DEVELOPMENT APPLICATION ASSESSMENT REPORT

Application Number:	DA2020/0024
----------------------------	-------------

Responsible Officer:	Maxwell Duncan
Land to be developed (Address):	Lot 27 DP 7435, 21 Tasman Street DEE WHY NSW 2099
Proposed Development:	Demolition works and construction of a dwelling house including swimming pool
Zoning:	Warringah LEP2011 - Land zoned R2 Low Density Residential
Development Permissible:	Yes
Existing Use Rights:	No
Consent Authority:	Northern Beaches Council
Land and Environment Court Action:	No
Owner:	Thomas Keith Sawyer
Applicant:	Thomas Keith Sawyer

D8 Privacy

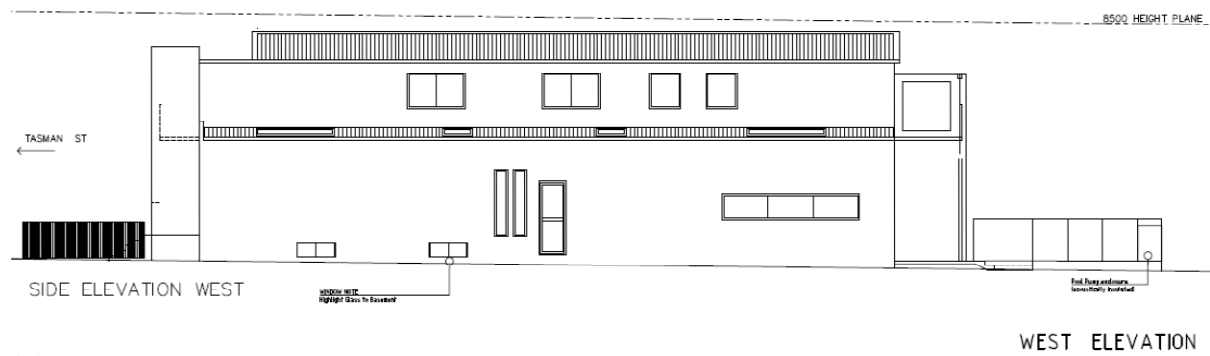
The adjoining property to the west (No. 19 Tasman Street, Dee Why) raised concern with potential direct overlooking to ground floor highlight windows.

The proposed first floor windows (labelled as W33, 34, 35 and 36) are located off bedroom and bedroom 1 en suite. It is noted that these rooms are not a intense room use. While it is evident that there may be some sightlines to the ground floor windows of No. 19 Tasman from these windows, the sight lines are not considered the dominant views. The windows are of a reasonable size and have been sited appropriately so as to not directly overlook private open space or living room windows of neighbouring properties. The expectation of complete privacy is not reasonable in this circumstance. Suitable visual privacy is maintained between the subject site and neighbouring properties.

The proposed use of high sill windows on both the east and western wall in conjunction with offset position of windows on the western side of the dwelling reflect a design solution which has considered amenity of both the subject site and surrounding development. The proposed design will improve the streetscape of Tasman Street.
